**ADDENDUM NO. 01**

August 14, 2020

**TO THE CONTRACT DOCUMENTS FOR
John Knight Middle School Kitchen Renovation and Window Replacement Project
FOR THE
DIXON UNIFIED SCHOOL DISTRICT****NOTICE TO BIDDERS**

Addendum 1 - ASK01.2
8/14/2020
Glazing Clarification

BLDG. A - SOUTH ELEVATION / EAST 2

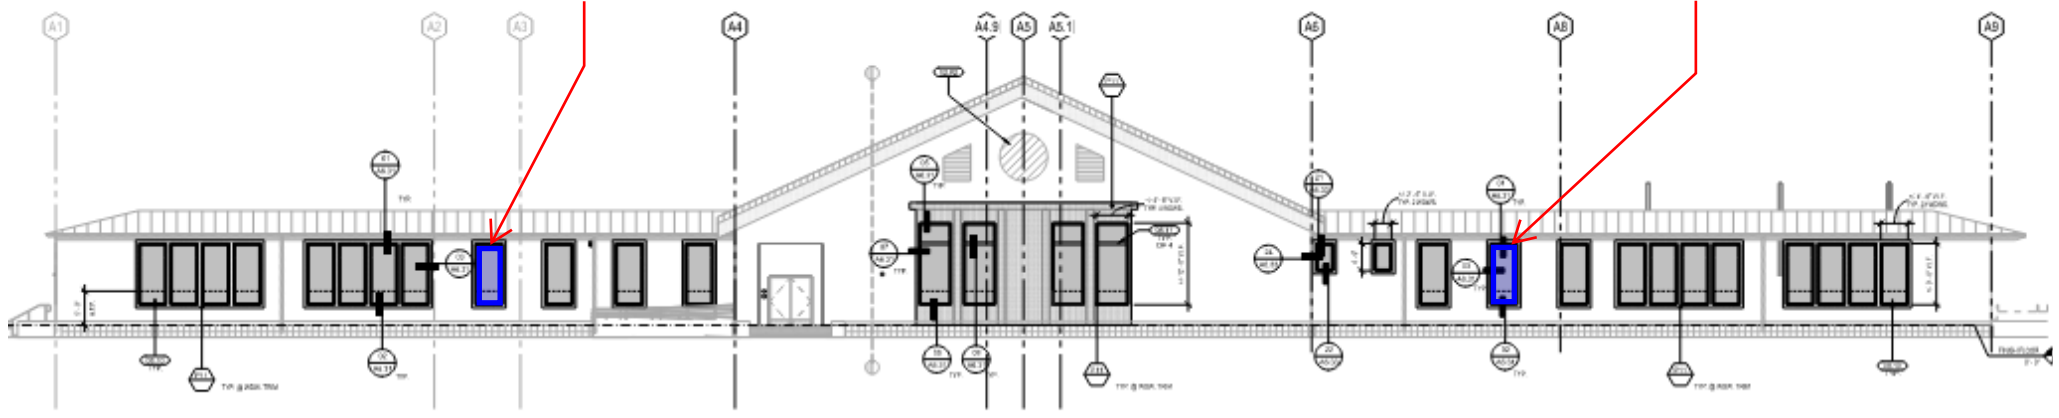
- ITEM NO. 1** Building A: Restroom Windows at rooms A105 & A125 are modified to be IG-2 insulated glazing unit to provide visual opacity/obscuring with Sandblast/Etched inner panes. Insulated Glazing Unit type IG-2, per attached **Addendum 1 ASK-01.**

Girls Restroom
Room A105
Glazing Unit: IG-2

Boys Restroom
Room A125
Glazing Unit: IG-2

D. Type IG-2 Insulated Glass Units: Translucent Sandblast, double glazed.

- A. Double Glazed Clear Solar Control Etched Insulating Glass Unit [Solarban® 60 on Clear 6mm (2) | Air 1/2" (12.7mm) | Etch/Sandblast (3) on 6mm Clear]
